TECHNICAL BULLETIN

[Issue No.] FA-A-0105

[Title] Corrections in manuals supplied with the Q64AD, Q68ADV, or Q68ADI

[Relevant Models] Q64AD, Q68ADV, and Q68ADI

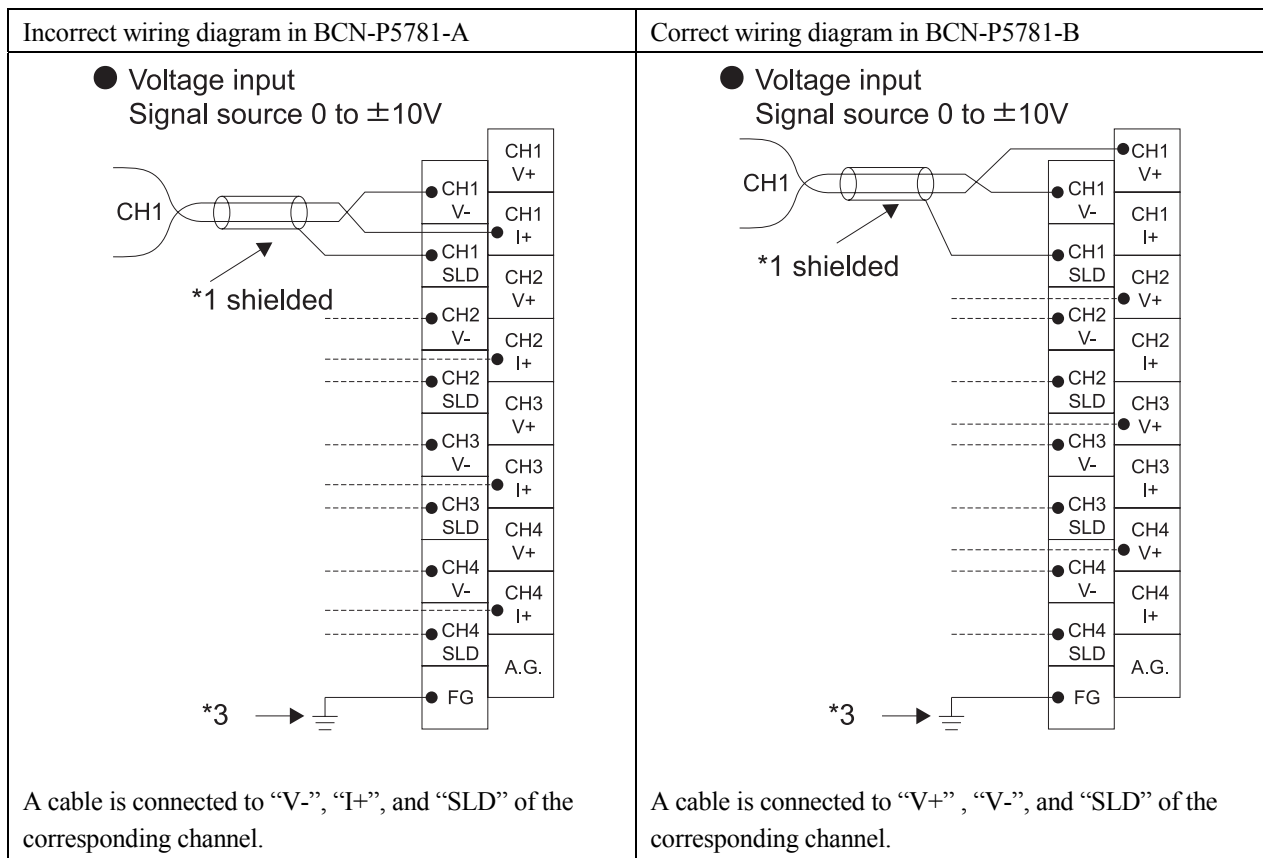
This bulletin provides information on a correction of a wiring diagram for the Q64AD in the manual, Before Using the Product (BCN-P5781-A), supplied with the Q64AD, Q68ADV, or Q68ADI since August, 2010.

The wiring diagram for the Q64AD is corrected as follows.

When the Q64AD is incorrectly wired as shown above, it is regarded as not-wired. The module will not fail even when incorrectly wired.
